**BRIDGEVIEW
PLANNED DEVELOPMENT NO. 67
BASE ZONING DISTRICT: MF-3 MULTI-FAMILY
ORDINANCE NO. 24-03-01-10
(ADOPTED 3-7-2024)**

- **PDA23-0008: MINOR PD AMENDMENT FOR SITE DESIGN CHANGES AND UPDATES TO DEVELOPMENT STANDARDS (APPROVED BY STAFF 10-1-2024)**

**CITY OF CORINTH, TEXAS
ORDINANCE NO. 24-03-07-10**

Minor PD, Planned Development Amendment Application*

EXHIBIT C
PD CONCEPT PLAN
 THE BELTON
 CORNITH, TEXAS
 DENTON, COUNTY, TEXAS
 MAY 2024

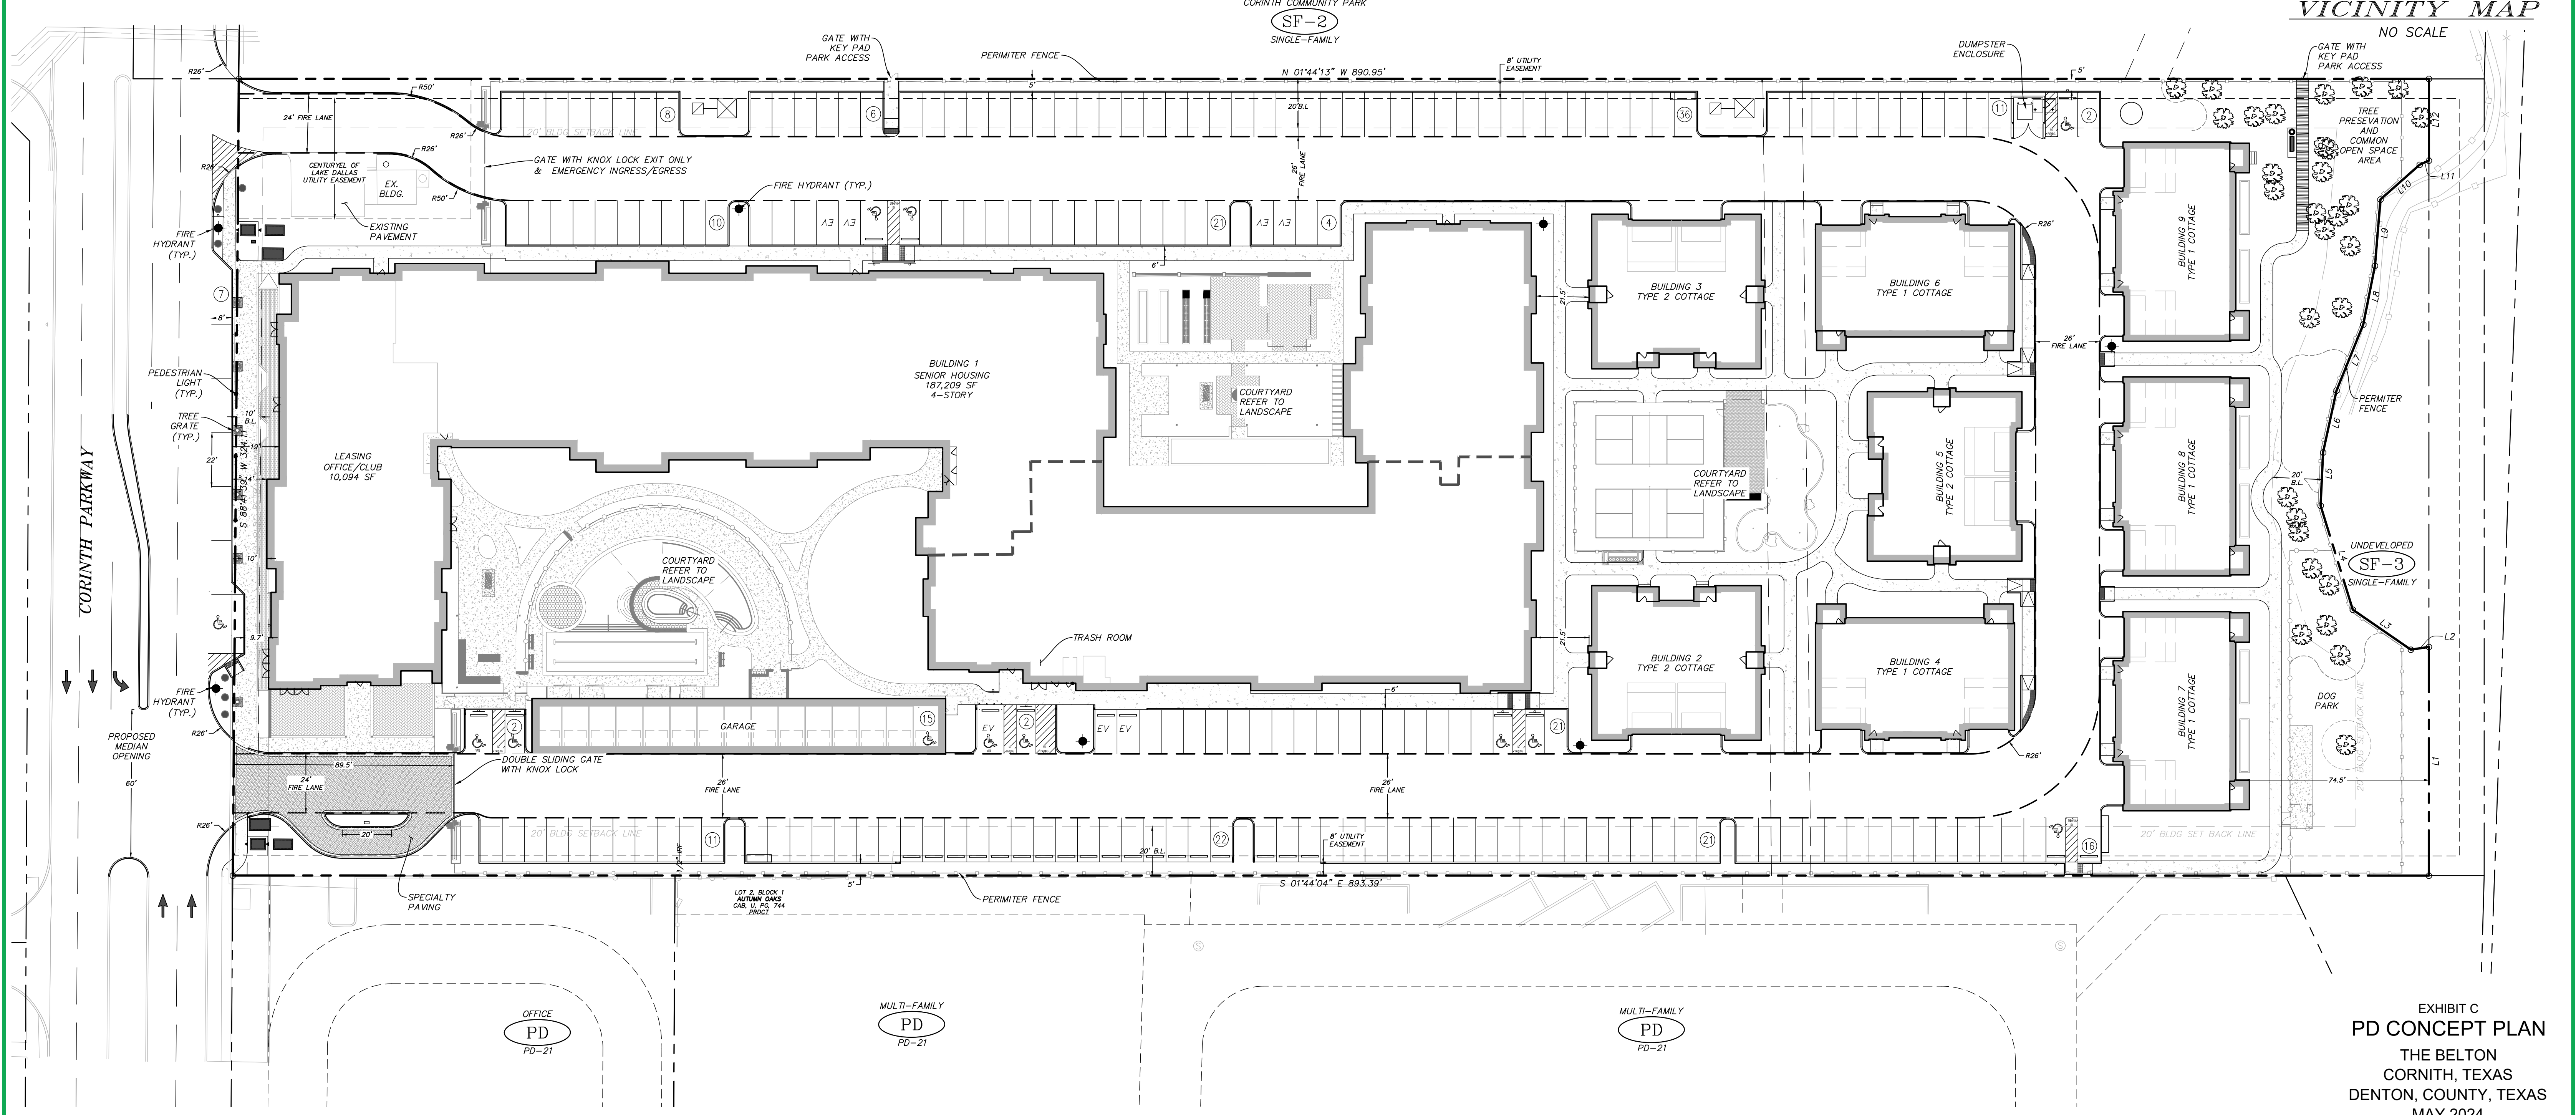
10. Amend Section 2.P. to read as follows: UDC Section 4.02 Fence and Screening Regulations shall apply, except that 4.02.11.E Residential Construction Abuts a Collector or an Arterial Street shall not apply. Additionally, perimeter fencing as depicted on the PD Concept Plan (Exhibit "D") shall be comprised of a transparent decorative iron fence with pedestrian gate access along the **eastern property line**.

11. Amend Section 3.D. to read as follows: **Fire Lane:** A **fire lane** as depicted on the PD Concept Plan (Exhibit "D") shall be installed providing **exit only for residents and emergency access**. The type of gate shall be determined at time of Site Plan and be acceptable to the Fire Marshal though at a minimum would be a one-armed gate (or similar).

12. **Other: Regarding the on-street parking design shown along Corinth Parkway on "Exhibit B" – PD Concept, the developer agrees to revise the proposed design should the City present an alternative plan for on-street parking and the associated sidewalk prior to the construction of said on-street parking. Additionally, a pedestrian access easement shall be provided along Corinth Parkway extending from the property line inward to the back edge of the sidewalk.**

Justification: Clarifying the correct property line on where pedestrian gates are to be located.

Justification: Removed reference to the grasscrete fire lane and modified how the easternmost drive should function.

LANDSCAPE ORDINANCE PLAN - NOTES AND CALCULATIONS

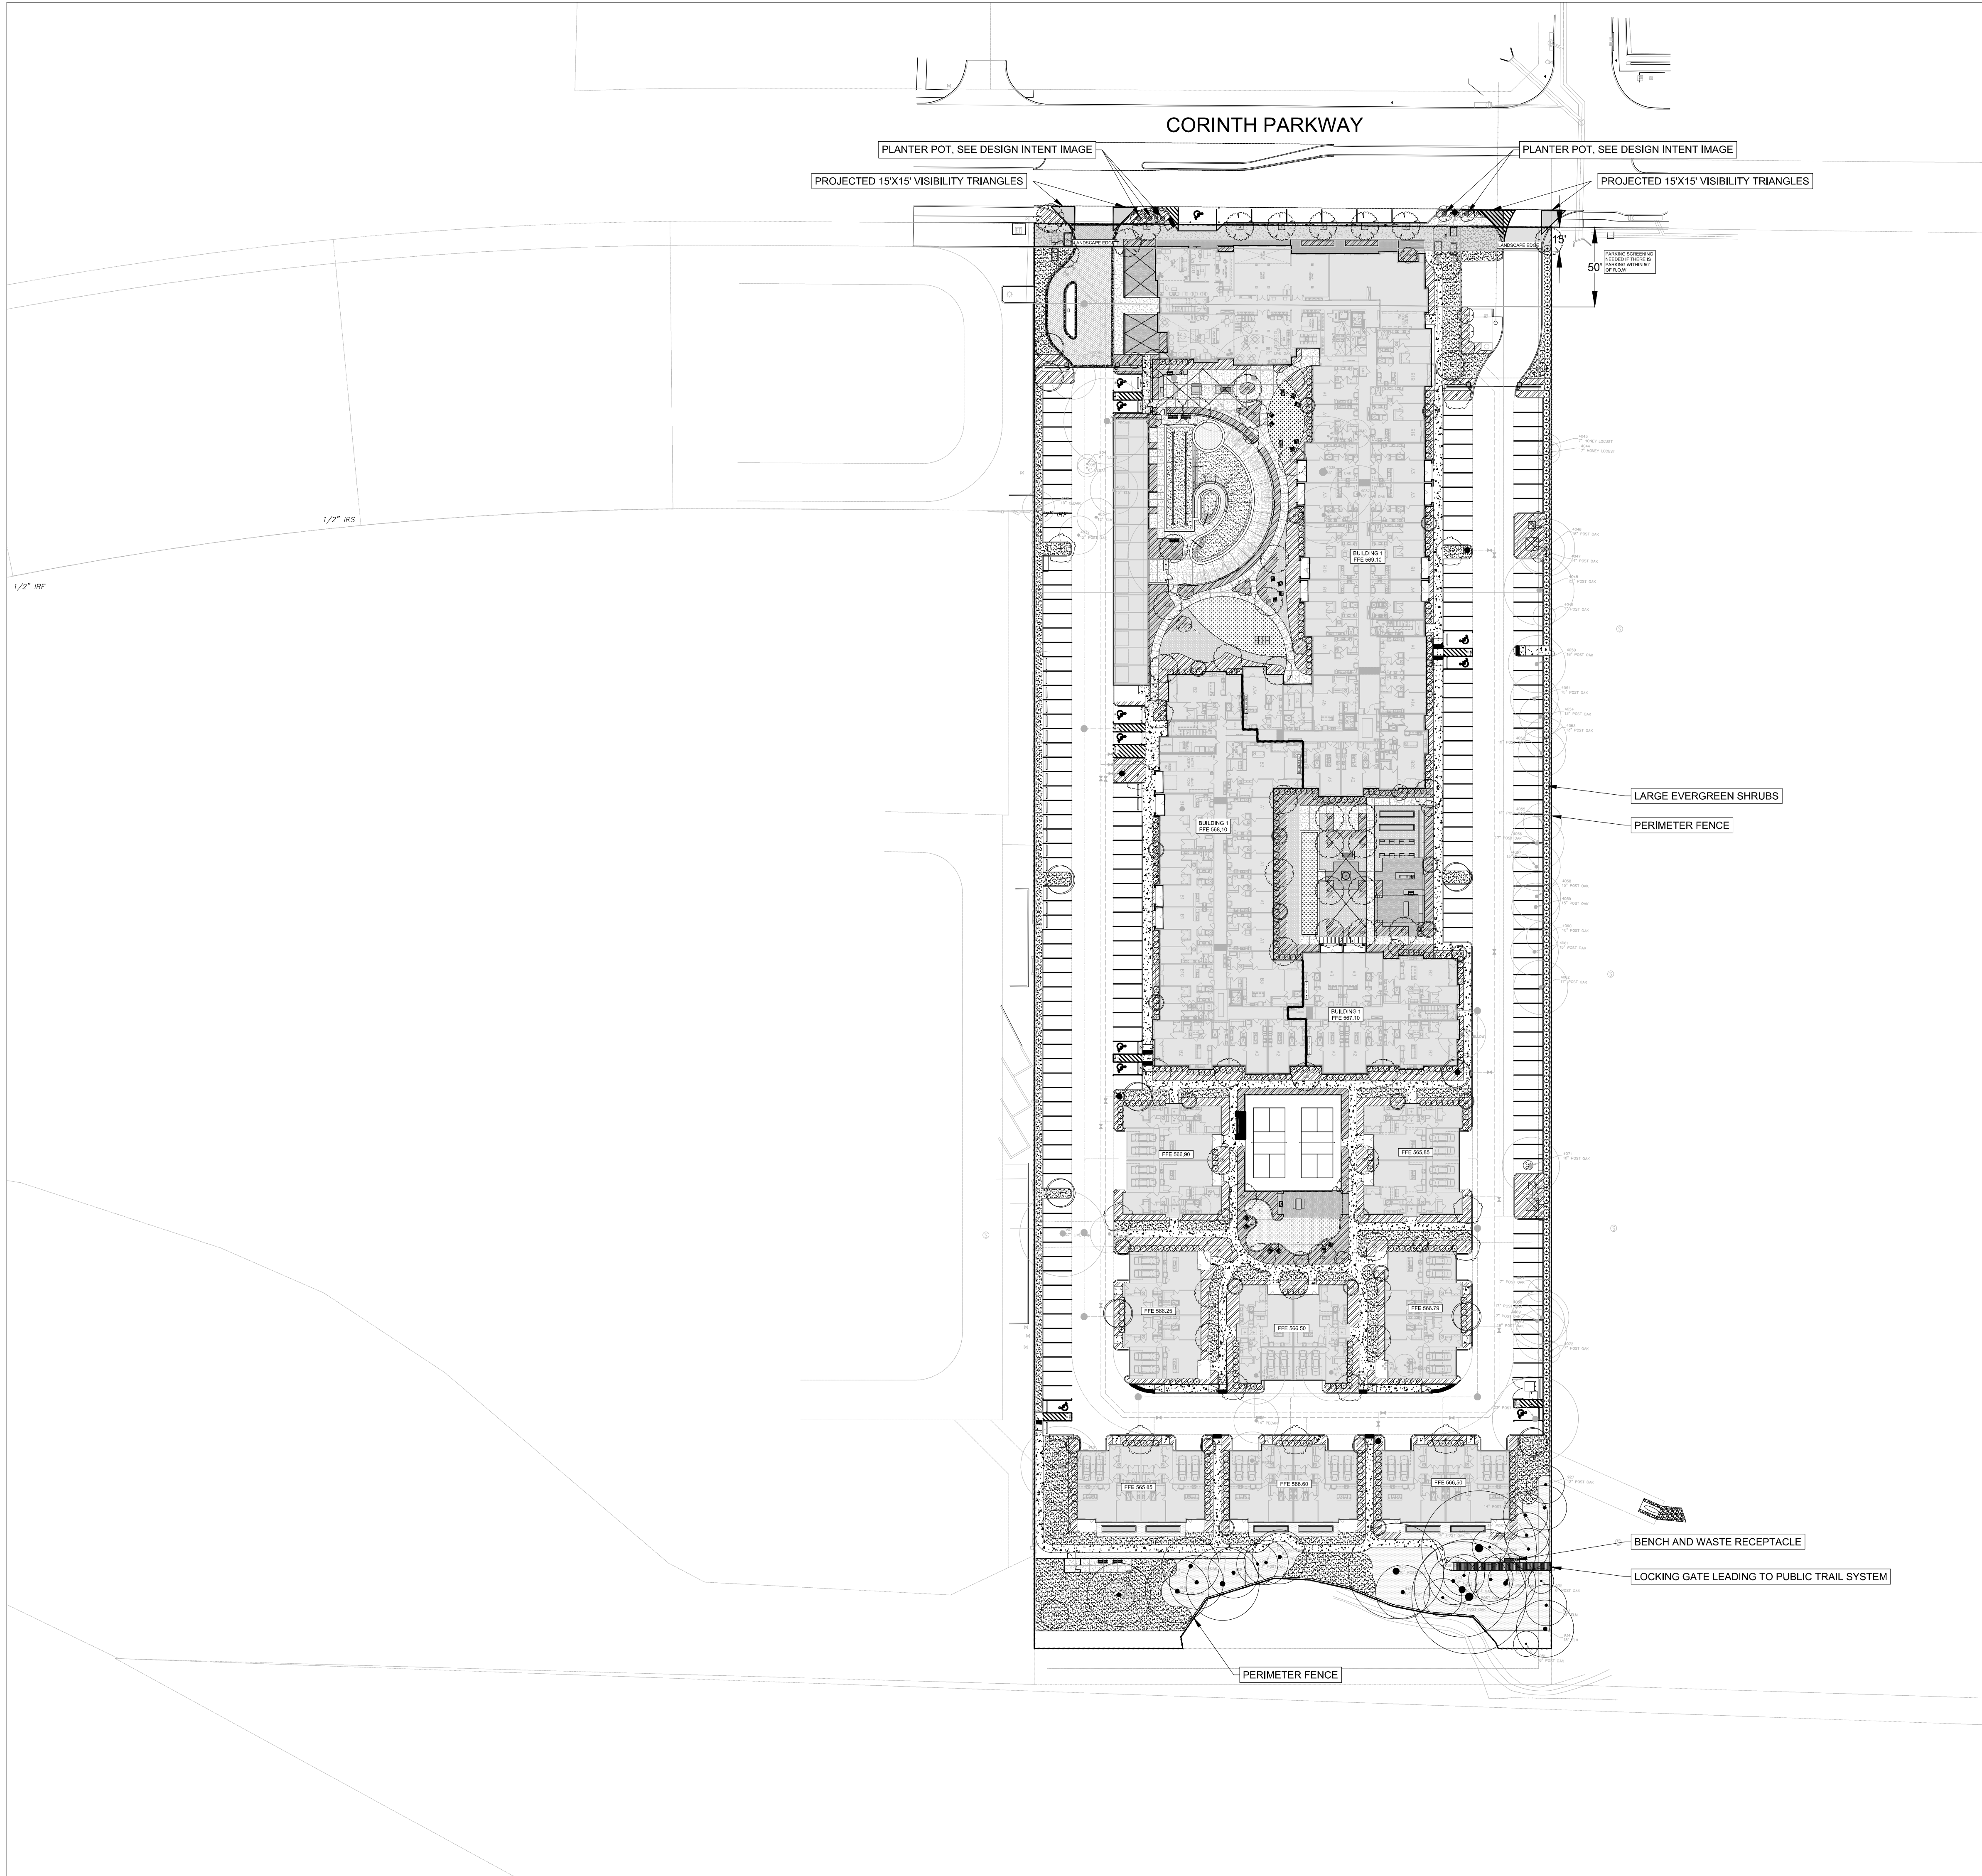
- Amend Section 2.E to include the following: **UDC Subsection 2.09.01.B.1.e shall apply except that decorative gravel shall be allowed as a ground cover material as depicted on Exhibit "E" PD Landscape Plan.**

- Amend Section 2.E to include the following: **UDC Subsection 2.09.01.E.1 shall apply except artificial turf may be utilized in areas as depicted on Exhibit "E" PD Landscape Plan.**

4. Amend Section 2.E.2.a. to read as follows: A **variable width** landscaped strip, **excluding driveway areas, as depicted on Exhibit “E” PD Landscape Plan** shall be provided along all facades of each building as measured from the foundation. The landscaped strip area shall be planted at a minimum rate of one (1) Ornamental tree and eight (8) shrubs (may include a mix of evergreen and deciduous) per ground floor unit and may **be** grouped along the façade to create rhythm, variety, and visual interest along the length of each façade. **Where the prescribed planting rate cannot reasonably be accommodated within the variable width landscape strip, required plantings may be installed outside the landscape strip as depicted on Exhibit “E” PD Landscape Plan.**

***Justification:** To reduce the amount of impervious cover/hardscape we have proposed, we are proposing to soften our courtyard with areas of decorative gravel to be used for lounge and connections between spaces. This also allows us to blend our planting beds with these spaces to create a seamless connection instead the hard break that would come with hardscape materials and steel edging.*

EXHIBIT G
**PRIVATE RECREATION
 OPEN SPACE PLAN**
 THE BELTON
 CORNITH, TEXAS
 DENTON, COUNTY, TEXAS
 MAY 2024

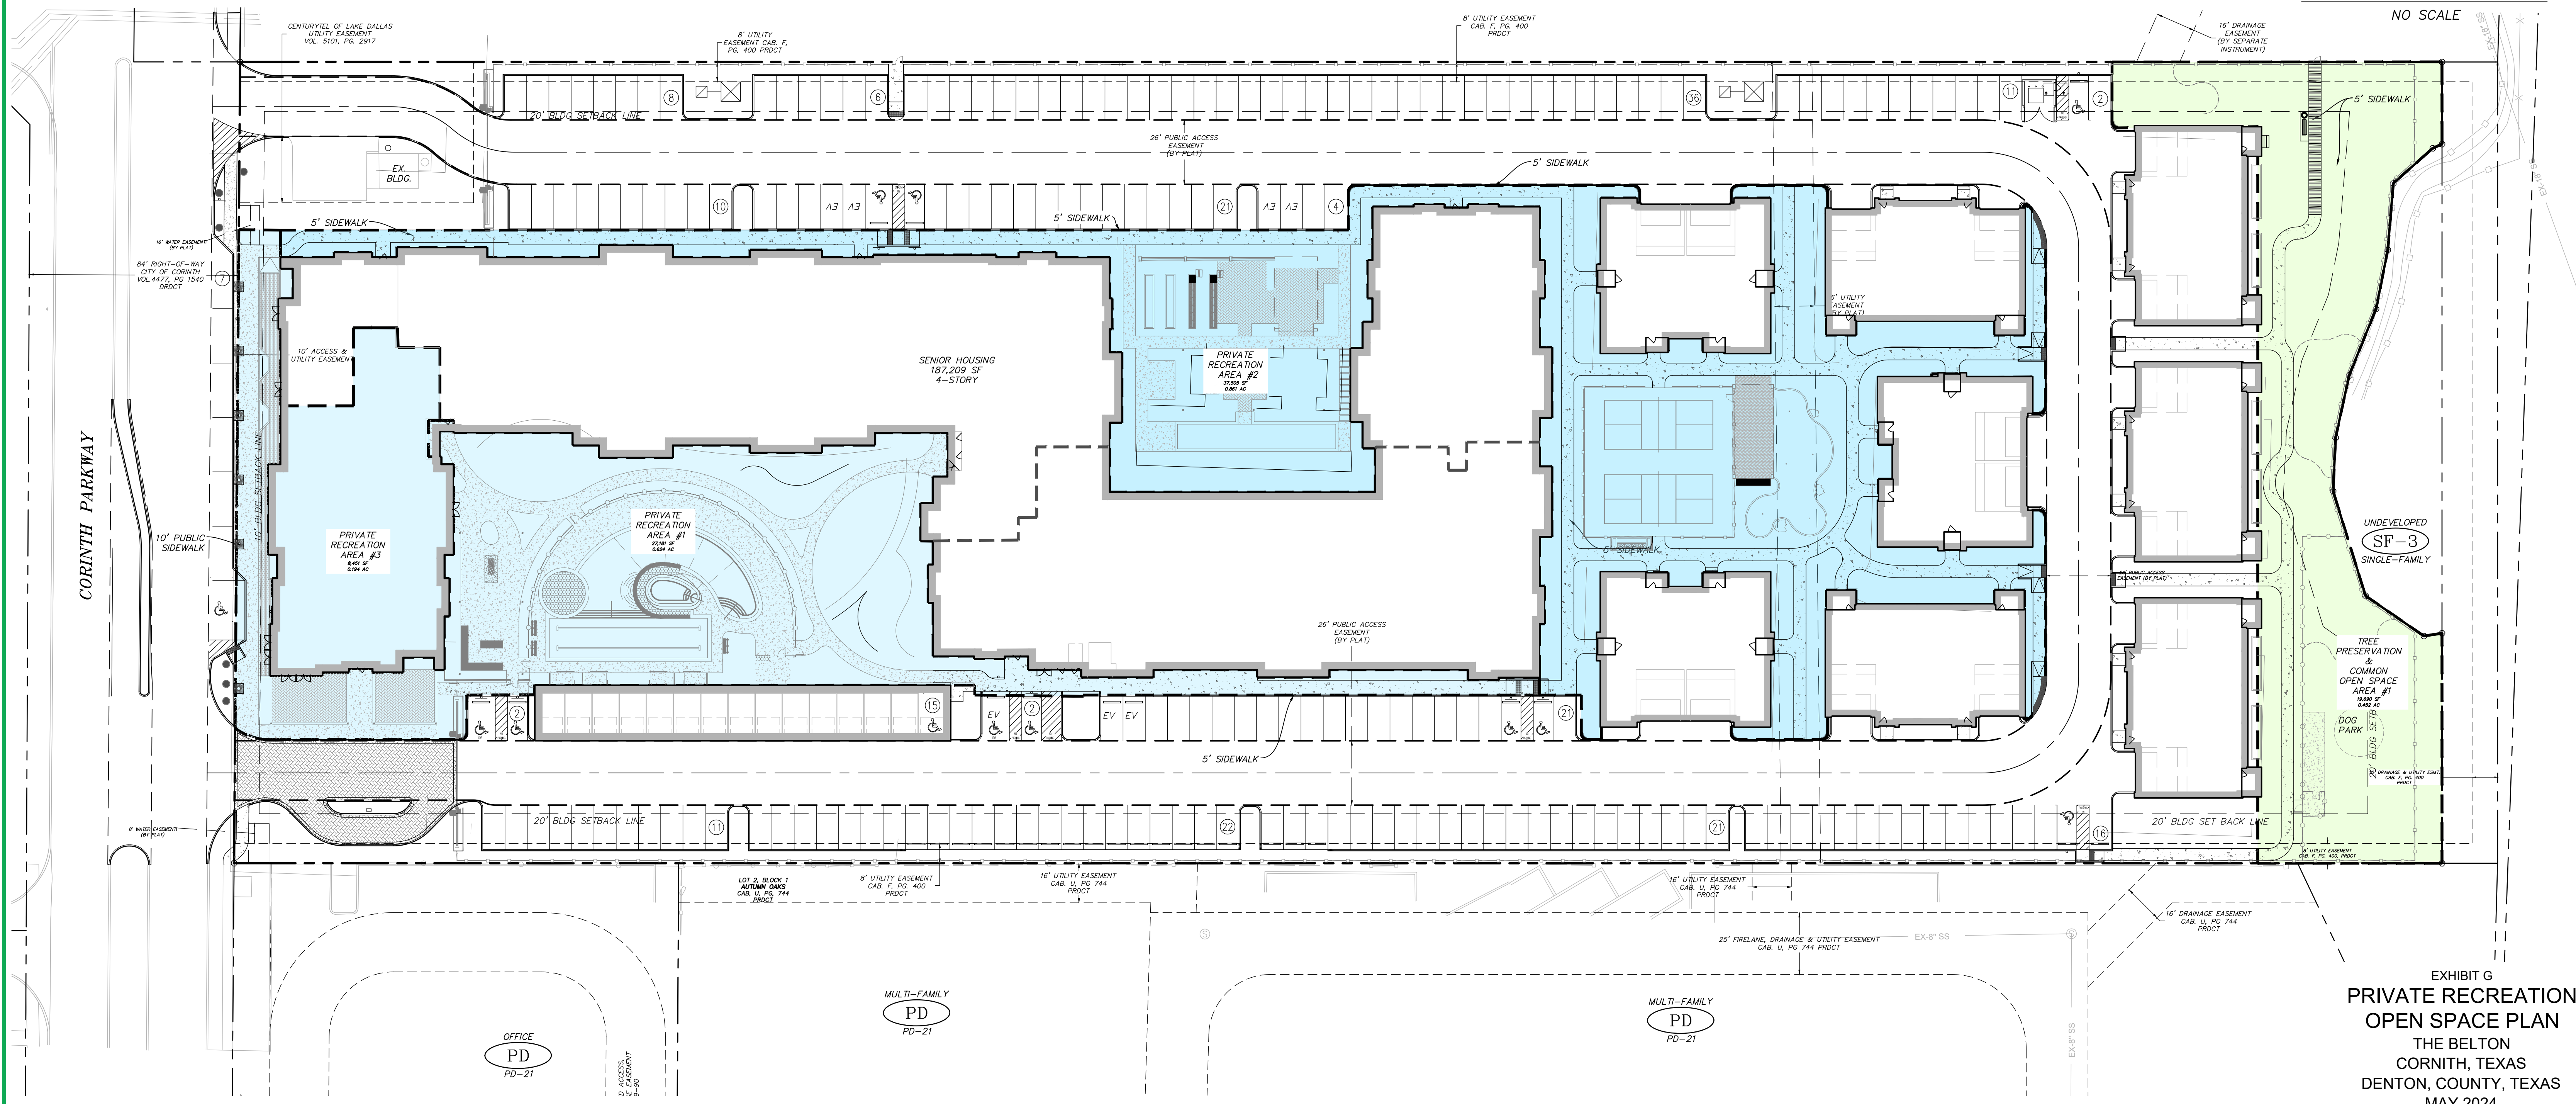
Justification: The overall tree preservation area increased by 58 sq. ft. This is due to changes in the site plan.
